Advice to decision maker on coal mining project

IESC 2019-110: Bulga Optimisation Project MOD 3 / Bulga Underground Operations MOD 7 (EPBC 2018/8300 and SSD 4960 / DA 376-8-2003) –Expansion

Requesting agency	The Australian Government Department of the Environment and Energy The New South Wales Department of Planning, Industry and Environment
Date of request	1 November 2019
Date request accepted	1 November 2019
Advice stage	Assessment

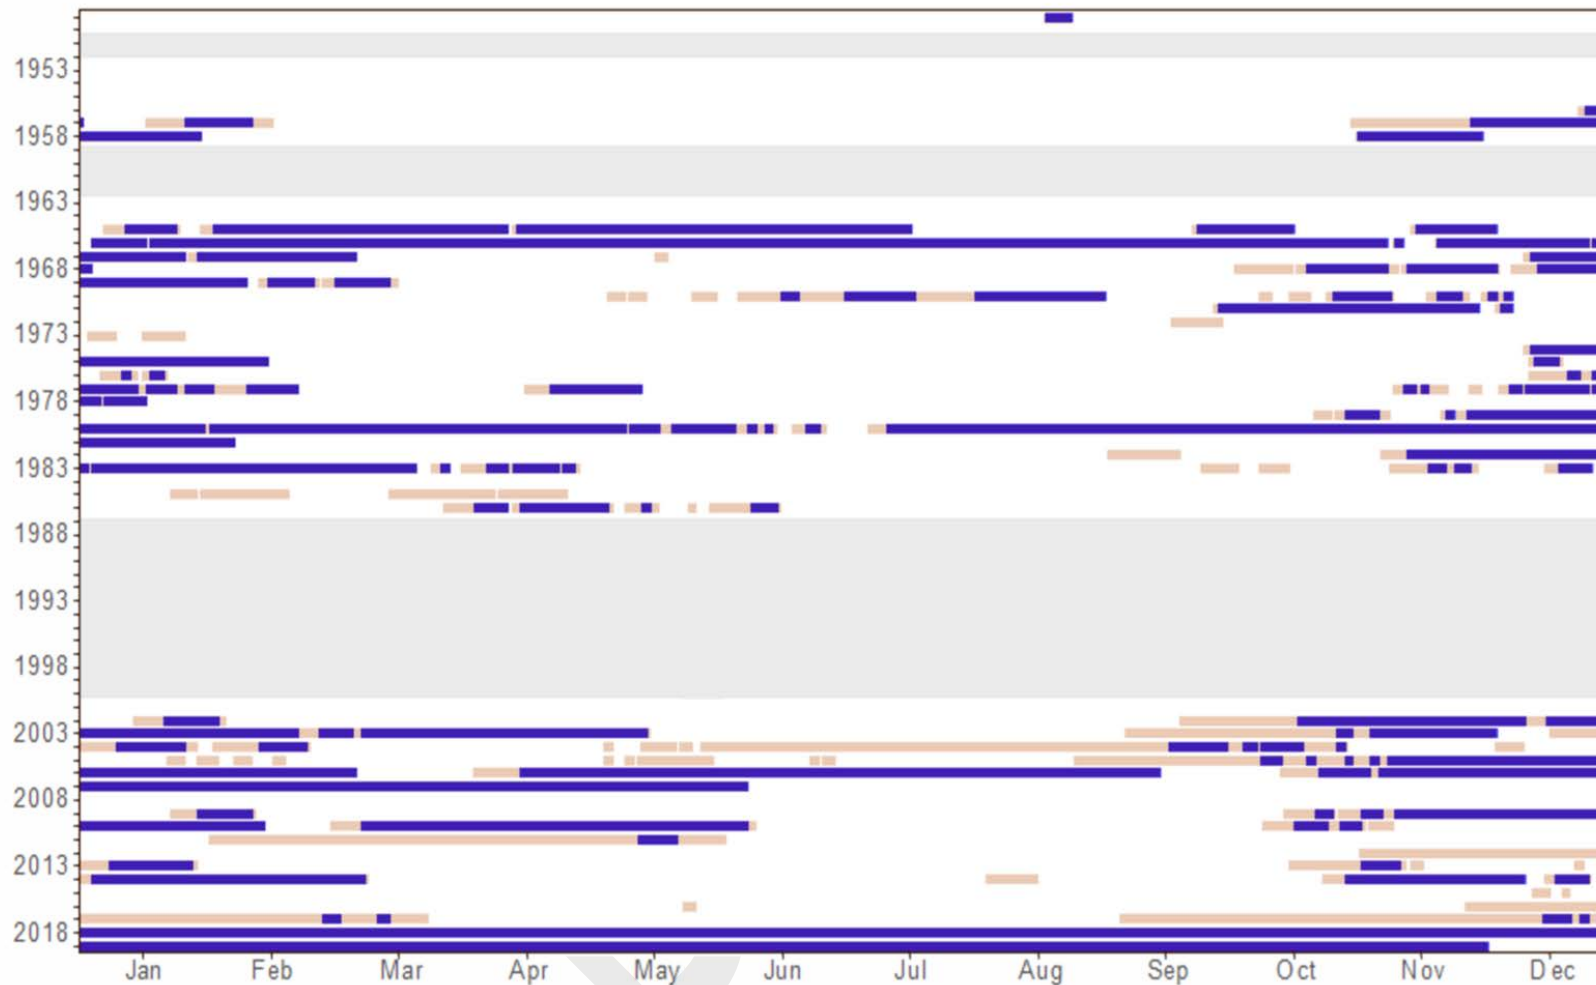
- 4. The surface water assessment modelling concluded that the impacts on baseflows were negligible as they represent a reduction in flows of less than 1%. However, reporting baseflow decreases as a volumetric proportion of the average fails to recognise the potential impacts on ecologically important aspects of the flow regime (e.g. impacts on the frequency, duration and timing of low- and zero-flow periods). Analysis of the groundwater drawdown impacts indicates that baseflow decreases of 1.38 ML/day will increase the number of zero-flow days by around 50%. The timing and duration of these impacts is illustrated in Figure 1 (Attachment A of this advice), where it is seen that the nature of these impacts on the flow regime are of material concern. For example, longer periods of zero- and low-flows will affect the completion of life cycles by aquatic stages of stream biota and maintenance of refugial pools. Evapoconcentration due to reduced flows may further increase salinity.
